Washington Public Power Supply System

January 9, 1986
G03-86-026

Subject: NUCLEAR PROJECT NO. 3
READINESS REVIEW PROGRAM
CONSTRUCTION ASSURANCE ACTIVITIES

SUPPLY SYSTEM RESPONSE TO NRC LETTER GI3-85-442
NRC QUESTIONS ON THE
WNP-3 CONSTRUCTION ASSURANCE PROGRAM

FIGURE 3

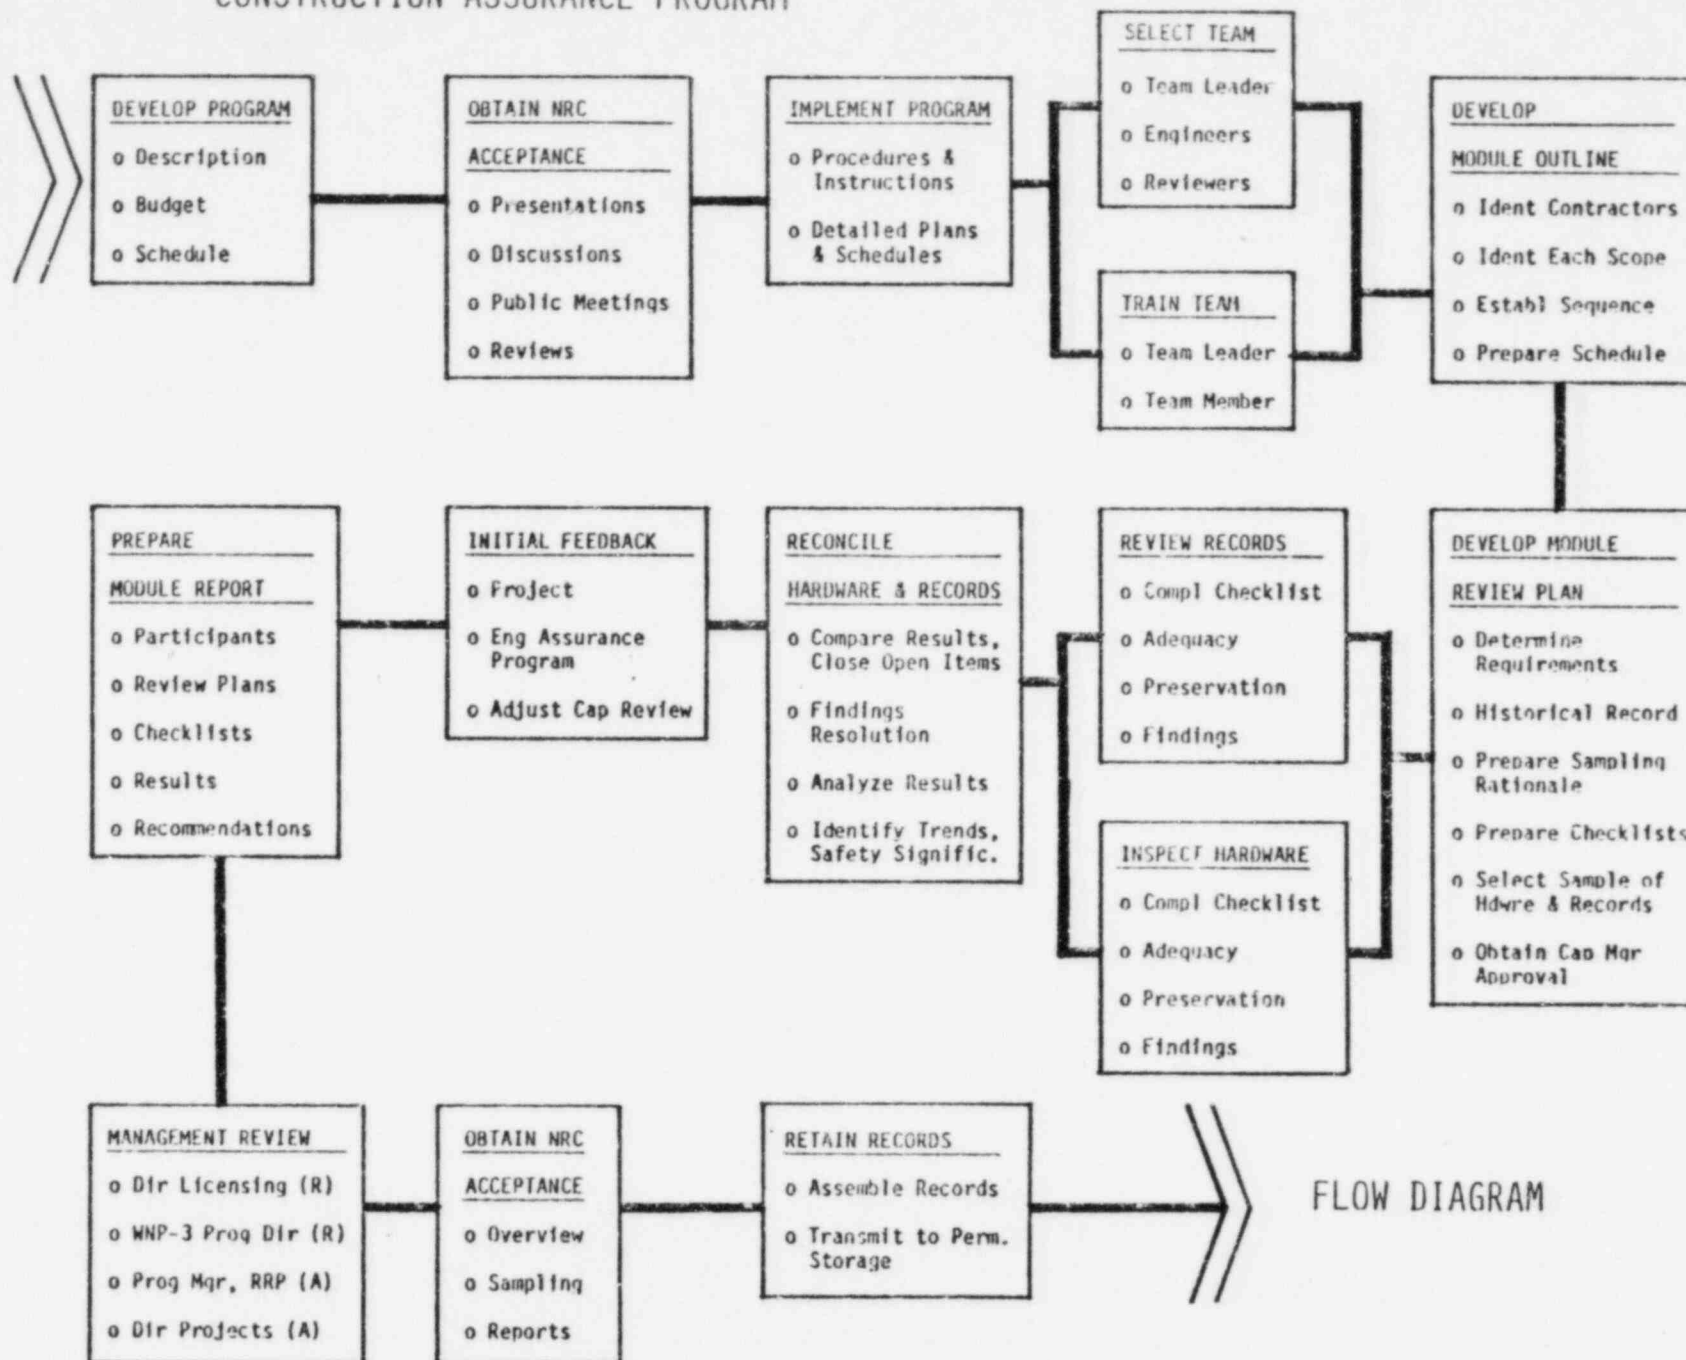
Include "Flow Diagram" presented as viewgraph in public meeting on October 29, 1985, with program description.

The CAP review process illustrated by the flow diagram shown in Figure 3 will be added to the program description.
